A Report for
Network Rail and ORR
from
Asset Management Consulting
Limited (AMCL)

Version 1.0
3rd June 2013

**Assessment of EAU Charge
Proposals
PR13 Review**

Figure 2 OLE Risk Based Maintenance Categories (extracted from NR/L2/ELP/21087)

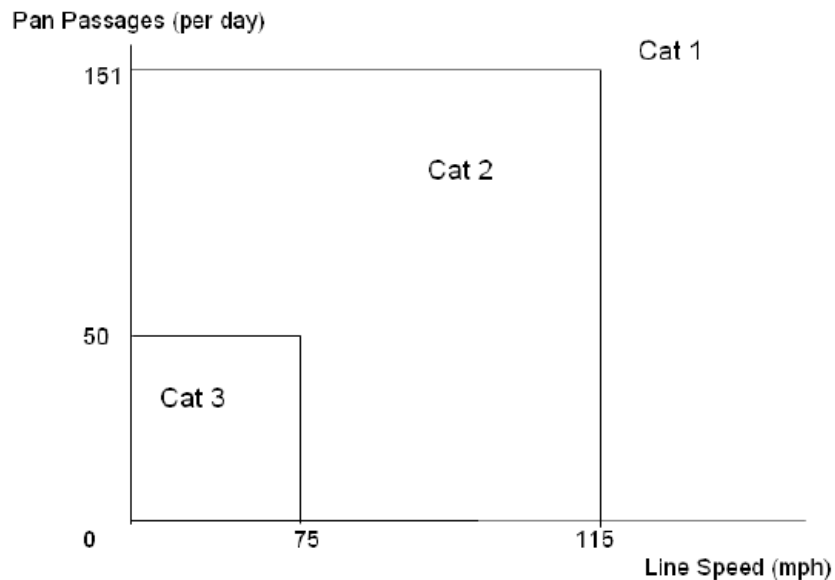
The logic behind Network Rail's determination of the 5% figure for variability in Maintenance is unclear to AMCL. It refers to standard NR/L2/ELP/21087 which contains the following rules for allocating the Maintenance regime for a section of OLE, based on the pan passages (per day) and the line speed.

The banding of the categories has not been fully explained. It would be expected that the cost for each Category would consist of a fixed amount and a variable amount. Of the variable amount, some will be attributable to line speed and some to utilisation (pan passages). Network Rail's analysis appears to try to estimate the impact of the 'Pan Passages' factor, but this does not take into account linespeed and it is not clear why the analysis is working from the above chart output rather than the underlying relationship between Pan Passage and the required maintenance activities. Given Network Rail's work in its modelling for the SBP it would be expected that these underlying relationships would be available.

AMCL has some further concerns about how Network Rail's logic is then translated into the overall percentage figure used for V2. The percentage of the overall charge which is attributable to usage varies by category, but there does not appear to have been an attempt to calculate how much of the overall network is in each category and use this to estimate the overall variability.

It is therefore recommended that this analysis is revisited and more clearly justified, or that this term is dropped from the variable charge until it is better demonstrated.
